**COMMONWEALTH OF KENTUCKY
DEPARTMENT FOR FACILITIES AND SUPPORT SERVICES
DIVISION OF ENGINEERING AND CONTRACT ADMINISTRATION**

INVITATION TO BID NO: RFB-156-12

FOR: Sprinkler System & Building Renovations
Western State Hospital
Hopkinsville, Kentucky

ADDENDUM NO.: Four (4)

AD3.2

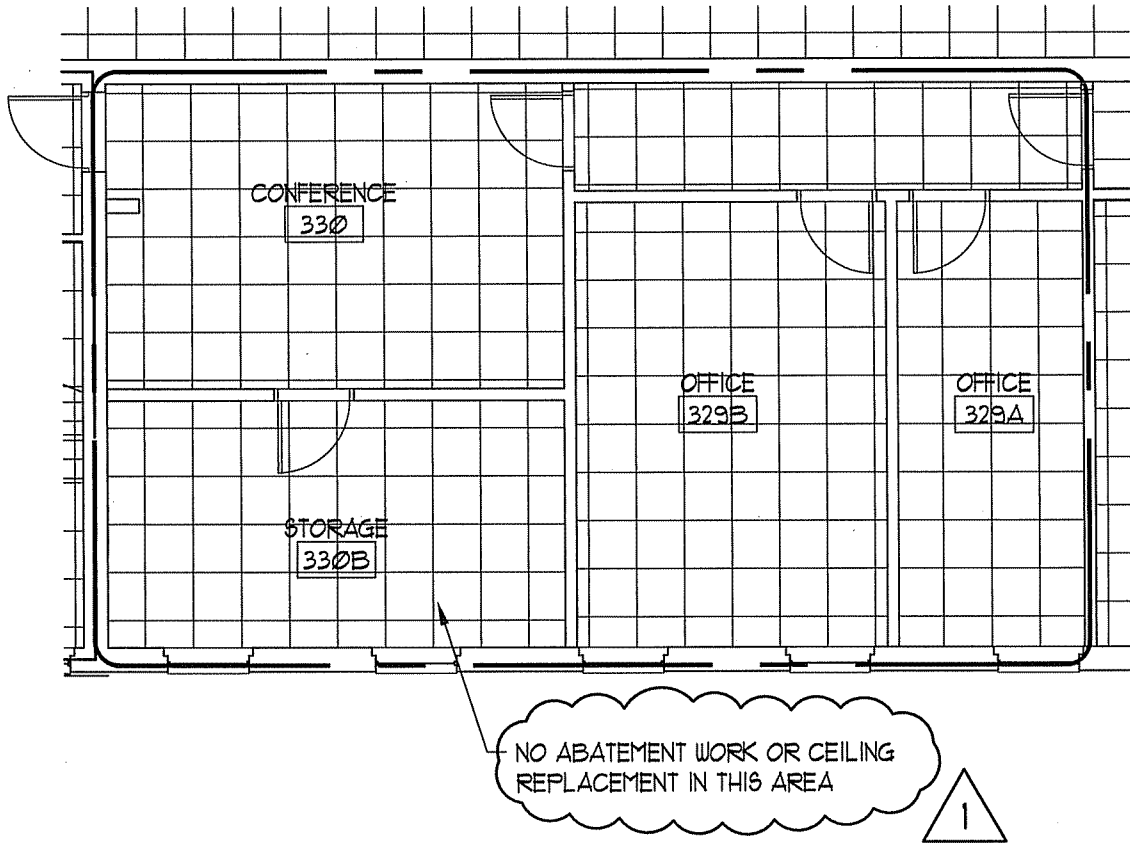
NOTE: REVISION MARKS MADE TO LEGENDS ON SHEETS A5.1, A5.2, A5.3, A5.4, A6.1, A6.2, A6.3 AND A6.4
